Access Compliance Report

Public Rights-of-Way

(Curb Ramps)

Intersection ID: 4511	Main Street: FRANK_VANCE_RD	Cross Street: PEPPER_ANN_LN	Location: NW
ADA ID: 310096324FE3	Ramp Type: Perp	Initial Pass/Fail: Fail	Overall Compliance: No
Severity Score: 12.5			
Codes/Mitigation Info/Possible Solution		Field Measurements/Component Compliance

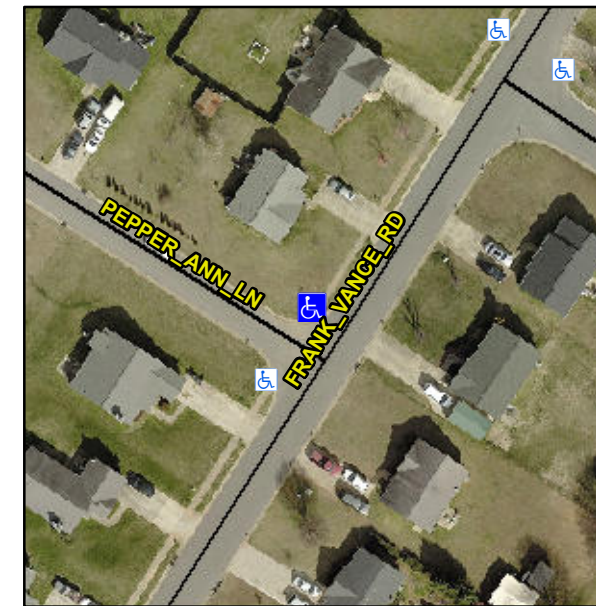
Not Found, R304.2.2

Compliance	Description	Data	Compliance	Description	Data
N/A	Ramp Length (in)	55.0	No	Ramp Slope (%)	9.8
Yes	Ramp Width (in)	48.0	Yes	Ramp XSlope (%)	0.3
N/A	Flare Type LT	N/A	N/A	Flare Type RT	N/A
N/A	Flare Slope LT (%)	N/A	N/A	Flare Slope RT (%)	N/A
N/A	Flare Traversable LT?	N/A	N/A	Flare Traversable RT?	N/A
N/A	Landing Length (in)	N/A	N/A	DWS Provided?	N/A
N/A	Landing Width (in)	N/A	N/A	DWS Contrast?	N/A
N/A	Landing Slope (%)	N/A	N/A	DWS Length (in)	N/A
N/A	Landing X Slope (%)	N/A	N/A	DWS Full Width?	N/A
N/A	Landing Curb? (Y/N)	N/A	N/A	DWS Offset (in)	N/A
N/A	Shared Landing?	N/A			
N/A	Gutter Ponding?	N/A	N/A	Gutter Slope (%)	N/A
N/A	Gutter Lip Ht (in)	0.8	N/A	Gutter X Slope (%)	N/A
N/A	Painted X Walk1?	No	N/A	Painted X Walk2?	N/A
	X Walk 1 Direction	To W		X Walk 2 Direction	N/A
N/A	X Walk 1 Width (in)	N/A	N/A	X Walk 2 Width (in)	N/A
	X Walk 1 Slope (%)	1.4		X Walk 2 Slope (%)	N/A
	X Walk 1 X Slope (%)	0.9		X Walk 2 X Slope (%)	N/A

Remove & Replace Entire Ramp.
